**Federal, Provincial and Indigenous information requests (IRs) to Canadian Nuclear Laboratories
on the Whiteshell Reactor-1 revised draft environmental impact statement (EIS) submitted December 2022
Version 2 (revised to include comments from Sagkeeng First Nation)**

May 2023

Table 1: CNL Responses to Federal, Provincial and Indigenous IRs on the draft Environmental Impact Statement, December 2022 (Acceptance of round 1 IRs). Round 1 IRs submitted to CNL December 2017, [TSD \(ceaa-acee.gc.ca\)](https://www.cnea-acee.gc.ca)

Table 2: Federal, Provincial and Indigenous follow-up IRs on the Draft Revised Environmental Impact Statement, May 2023 (Commencement of round 2 IRs)

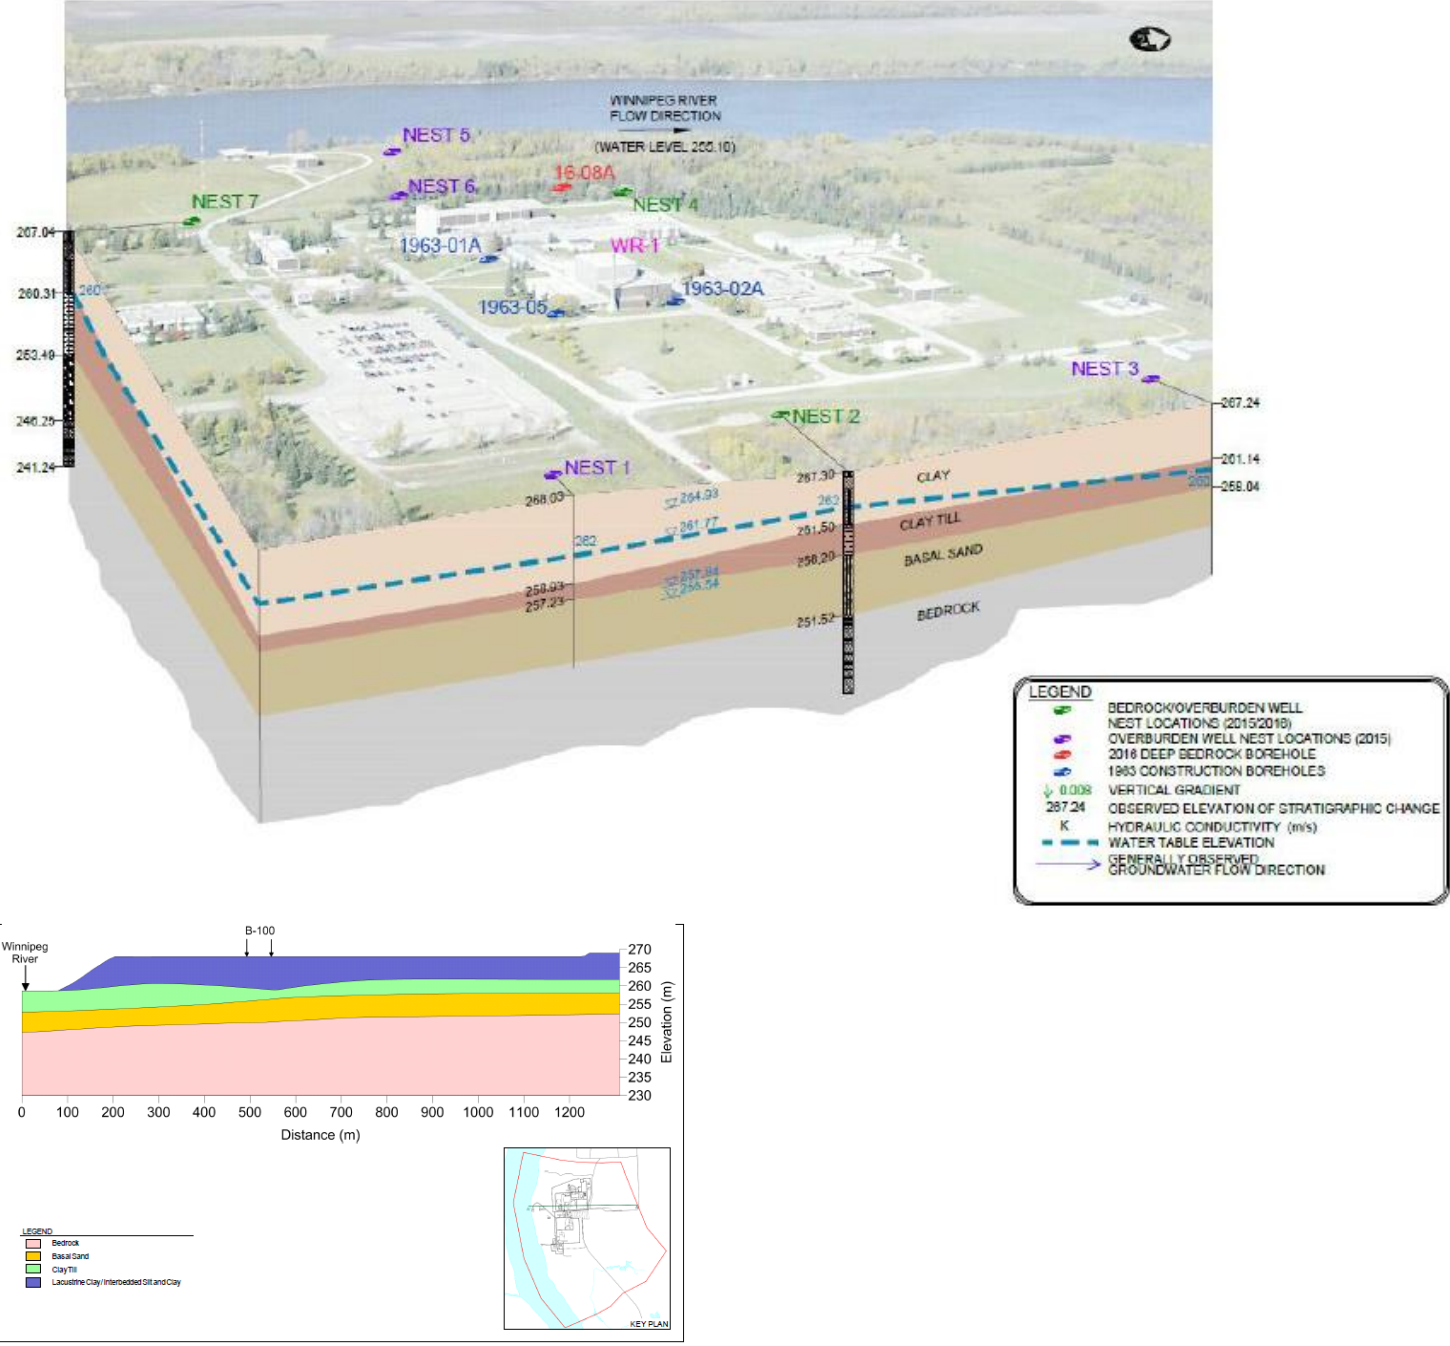
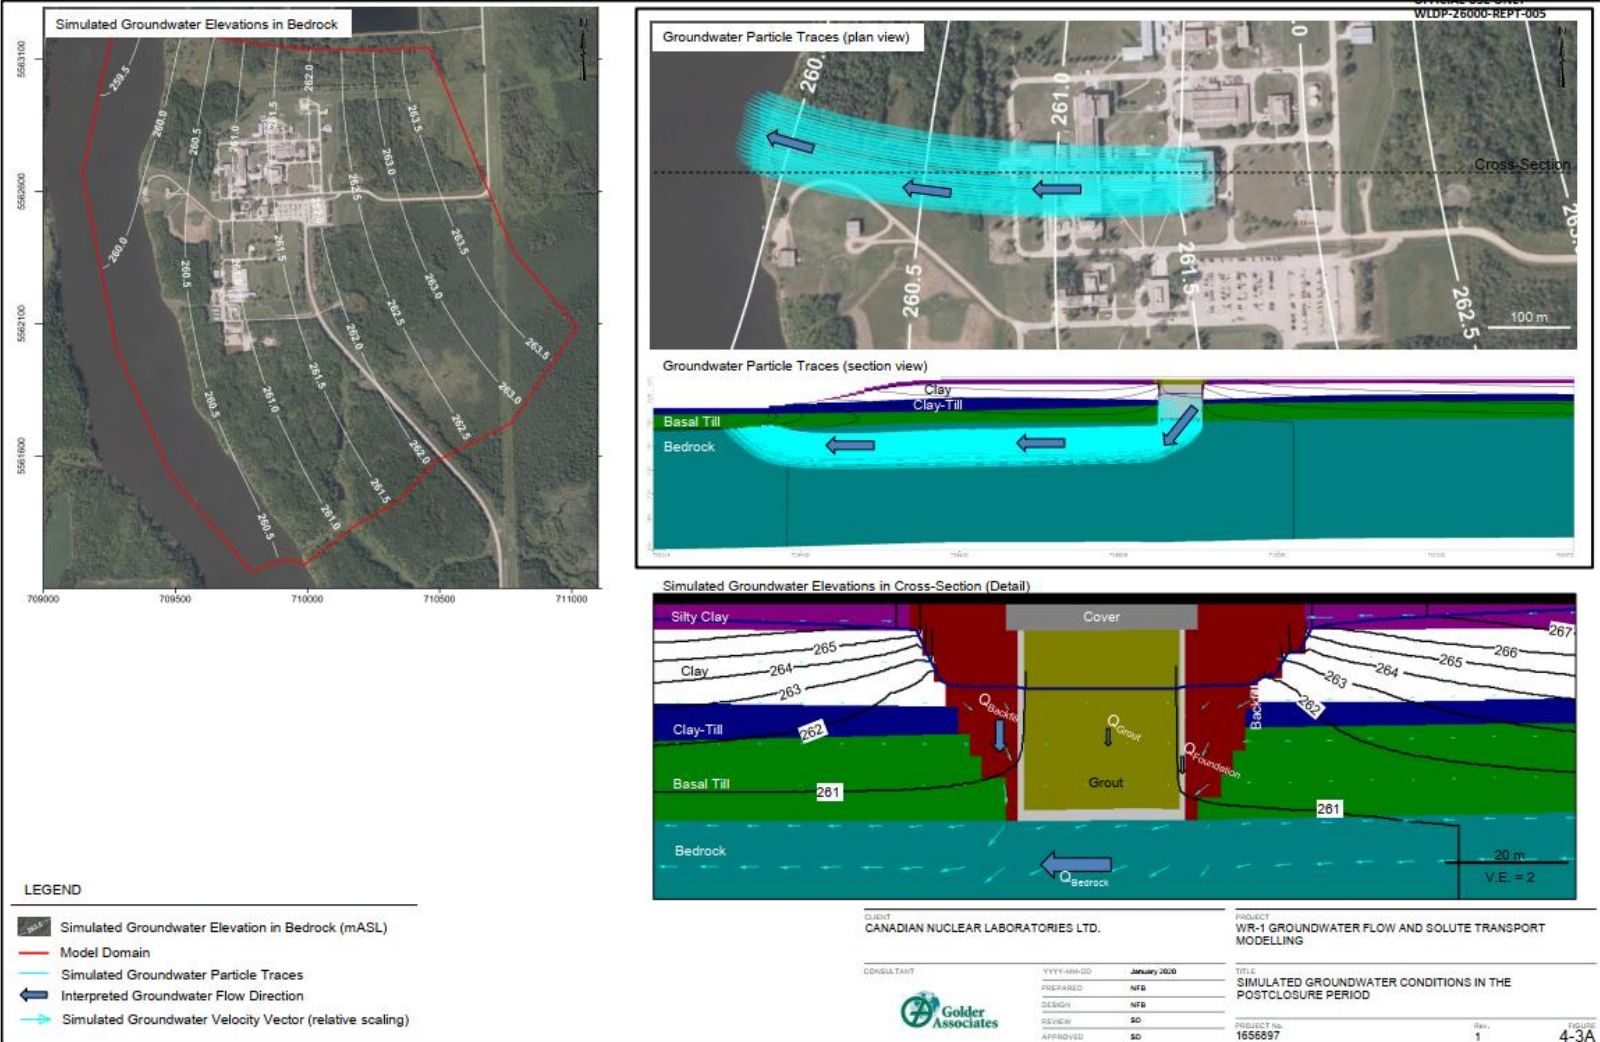
50.	CNSC	EIS - Section 3.5.4.1.5 Local Geosphere	<p>Comment: The baseline geological environment is inadequately characterized in the EIS (and supporting documents); it falls short of what is needed to assess the submission in light of the reliance of the project on the enclosing geological environment (for long-term safety). The compilation of existing geological information is limited; there is no geological</p>	<p>Incorporated:</p> <p>The term Entombment, within the context of its use in international guidance, is overly simplistic and is not appropriate to describe the WR-1 In Situ Decommissioning Project. WR-1 is being converted into a passively safe disposal facility, meeting all regulatory requirements for such a facility.</p> <p>To document the baseline geosphere characterization, CNL has prepared a Geosynthesis Report (CNL 2022) that includes the requested information. The geological information is also presented in Section 6.3.1 of the Environmental Impact Statement (EIS; Golder 2022) and has been updated to include additional information on structural geology and bedrock fractures.</p>	Follow-up IR from the CNSC

IR No.	Department/ Agency	Section Table or Figure	Information Request or Summary of Comment	Response by CNL	Accepted/ Request for follow-up information
			<p>so that CNSC staff can evaluate this important component of the safety case. This information is required to support the statement that local soils provide a barrier to contaminant release to the environment. One specific request includes providing a cross-section showing the relationship between the geology and the WR-1 facility to demonstrate and justify the importance of the geosphere barrier.</p>	 <p>The data in the Geosynthesis also supports the cross-sectional diagram used in Figure 4-3A (provided below) in the GWFSTMR (Golder 2021) that shows the WR-1 building in relation to the overburden and bedrock layers, as well as the effect the geological layers have on the transport pathways.</p>

PROJECT NO.	CONTROL	REV.	FIGURE
105057		2	6.3.1-10

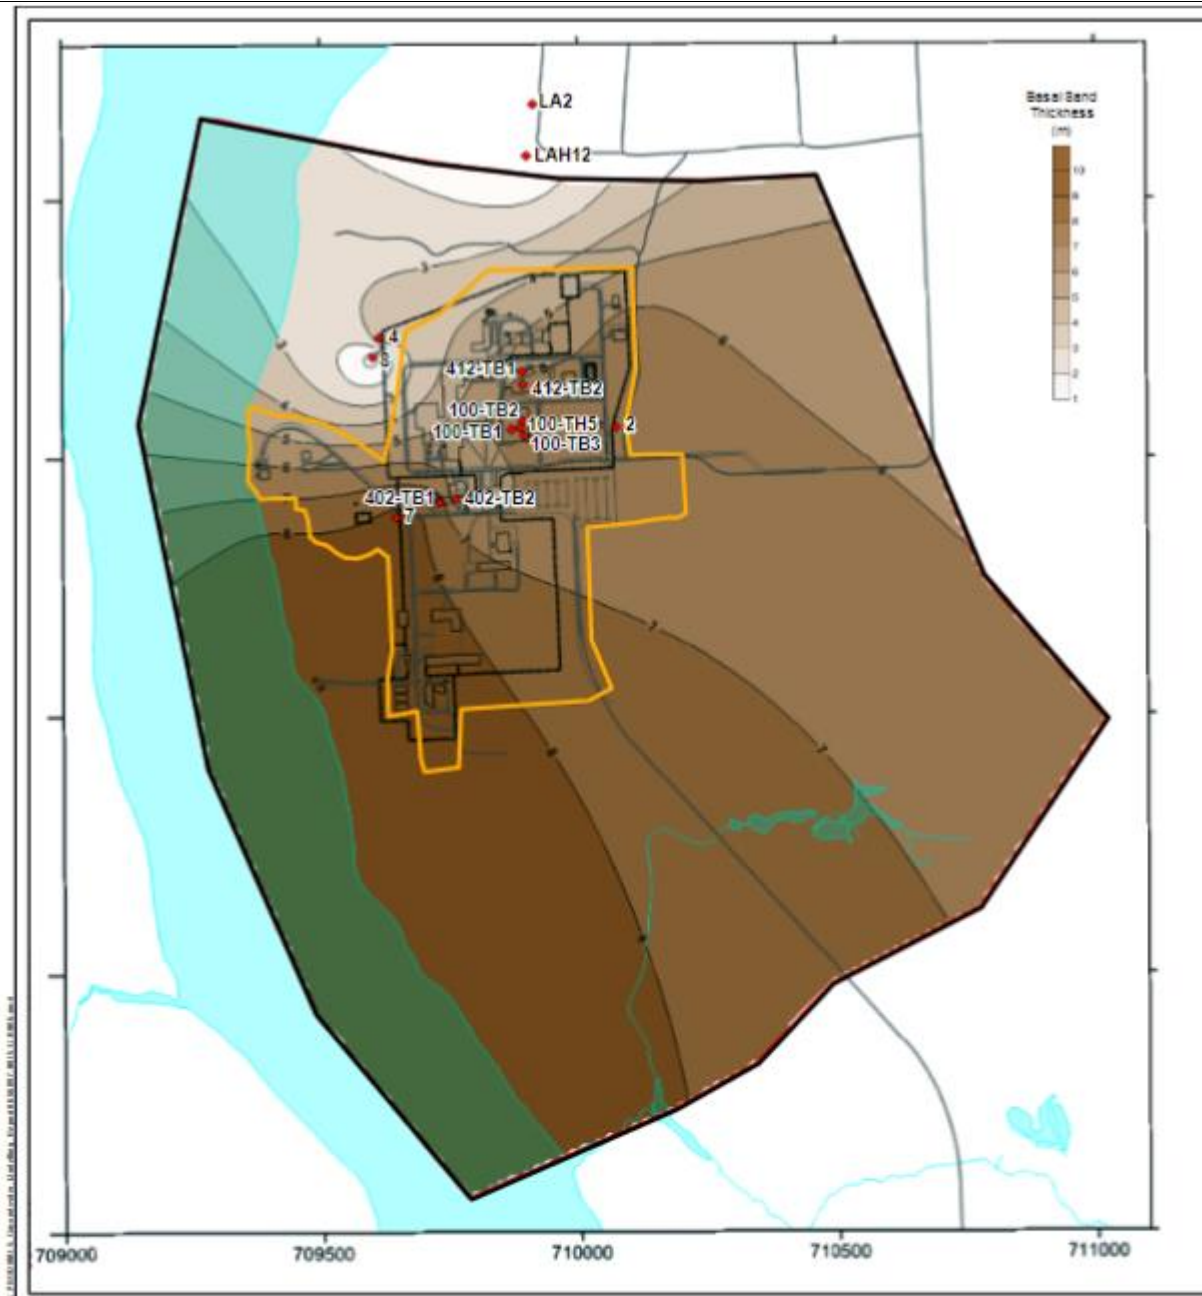
84.	CNSC	EIS - 6.3.1 Geology	<p>Comment: Geological data is missing or too descriptive, without evidence/observations to support statements made in the text, which are at times confusing or contradictory. For example: WN-series boreholes: P.6-77: baseline geological data were “collected from the results of recent drilling” described in Dillon 2017. The locations of the boreholes (names WN-1 and WN-2) are provided on Figure 6.3.1-3 (the scale is such that they are located in the same place) and the results very generally summarized on page 6-85. Where is the data for the WN series bedrock boreholes? It is not located in either the EIS or in the <i>Hydrogeological Study Report</i>. P.18 of the <i>Hydrogeological Study Report</i> describes two depth related zones in the bedrock, with “increased open-fractures in the upper 100m of bedrock”, and goes on to describe an overlying (upper?) 10m competent zone of less fractured rock overlying a zone with “increased fracture frequency approximately 30m into bedrock”. Then refers to the WN-series deep bedrock boreholes stating that the upper bedrock was</p>	<p>Resolved As:</p> <p>CNL has prepared a Geosynthesis Report (CNL 2022) that includes the requested information on the bedrock geology and fracture information.</p> <p>This report provides information to support the Whiteshell Reactor 1 (WR-1) Environmental Impact Statement (EIS; Golder 2022) in three areas:</p> <ol style="list-style-type: none"> 1. A Geosynthesis of the information used to support the EIS and licence amendment application for decommissioning of WR-1; 2. Ensuring that CNSC EIS regulatory baseline geological and hydrogeological requirements of Appendix B.4 of Regulatory Document 2.9.1 (CNSC 2020) and Section 7.3.1 of Regulatory Document 2.11.1 Volume III (CNSC 2018) are met; and 3. Identification of geoscientific data uncertainties and an assessment of their relevance/significance to the decommissioning project. <p>This Geosynthesis (CNL 2022) focuses on summarizing the available geological, hydrogeological and geomechanical information including published scientific literature, WL site characterization reports, information on the regional and local geology developed during the Canadian Nuclear Fuel Waste Management Program, government documentation of area soil and available mapping data from the Manitoba Geological Survey and Earthquakes Canada. Specifically, the summarized data provided in the Geosynthesis draws from and cites numerous reports related to the Underground Research Laboratory geological program. Hydrogeological information is contained in the WR-1 Hydrogeological Study Report (Dillon 2018) but is briefly summarized in Section 3.2 of the Geosynthesis (CNL 2022).</p> <p>The requested data for the WN boreholes indicated in Figure 6.3.1-3 of the EIS is summarized in Section 2.5 of the Geosynthesis (CNL 2022) and provided in the EIS (Golder 2022) in Figure 6.3.1-5. The original source data compiled in the Geosynthesis, including estimates of fracture frequencies, is gathered from reports prepared on the WN boreholes by Lau et al. (1980a, b, c, d, 1982 and 1985a, b.)</p> <p>The bedrock geology information, including the fracture frequencies, composition of the Lac du Bonnet batholith, its phases, regional setting and contacts with adjacent formations, has been synthesized and discussed in Section 2.5 of the Geosynthesis (CNL 2022). Specific to fracture zone locations and frequencies, Figure 6.3.1-5 in the EIS (Golder 2022) provides an overview of the fracture pattern from borehole WN-1, deemed to be</p>	Accepted

IR No.	Department/ Agency	Section Table or Figure	Information Request or Summary of Comment	Response by CNL	Accepted/ Request for follow-up information
			<p>content, grain size distribution curve for coarse-grained soils and consistency indices for fine-grained soils.</p>	<p>Within the Geosynthesis (CNL 2022), Table 6-2 – Geoscience Verification Plan outlines the uncertainties that are identified in the geological data, including soil erosion potential, and identifies the model sensitivity studies that verify whether the uncertainty is acceptable.</p> <p>Change to EIS:</p> <p>Additional text and figure were added to Section 6.3.1.5.2.2 of the EIS under the following sub-headings:</p> <p>“Glacial Till (also referred to as Basal Sand or Basal Till)</p> <p><i>Bedrock is overlain by a glacial till (referred to also as basal sand, silty sand till or basal till in other WR-1 in situ disposal documents) throughout the majority of the RSA [Regional Study Area]. The till varies from a silty coarse sand till to a clean medium to coarse sand (Cherry et al. 1970) and boulders are common above the bedrock surface. This unit is referred to as the “basal sand” in the area of the WR-1 Building (Dillon 2018) due to the increased sand content observed in this unit in other areas of the SSA [Site Study Area] (primarily the WMA [Waste Management Area]). Based on its grain-size distribution and hydraulic conductivity characteristics within the area of WR 1 it is not considered to be representative of sand.</i></p> <p><i>Based on the descriptions provided by McPherson (1968) and Robertson and Cherry (1985), the basal unit is characterized by variability in grain size. Results of grain size analysis on samples of this unit taken from the recently drilled boreholes in the vicinity of WR-1 (KGS Group 2016; plotted on Figure 6.3.1-9) indicated that this unit is primarily comprised of silt (content ranged from 26% to 56%), with the majority of most remaining particles categorized as fine sand (15% to 32%) and clay (5% to 24%). Water content for this unit ranged from 9% to 27%.</i></p> <p><i>In the WMA to the north of the LSA [Local Study Area], this unit has been found to vary in thickness from 1 m to 7 m thick (AECL 2008). At the LSA, this unit varies in thickness from 3.6 m to 8.3 m . In other areas of the RSA this unit appears to thin towards the Winnipeg River; however, surrounding the SSA this unit appears to be thickest to the southwest and thins to the north. This unit is thinnest over the local bedrock high in the vicinity of monitoring well nest 4 and borehole 16-8. A basal sand isopach is shown on Figure 6.3.1-10.</i></p>
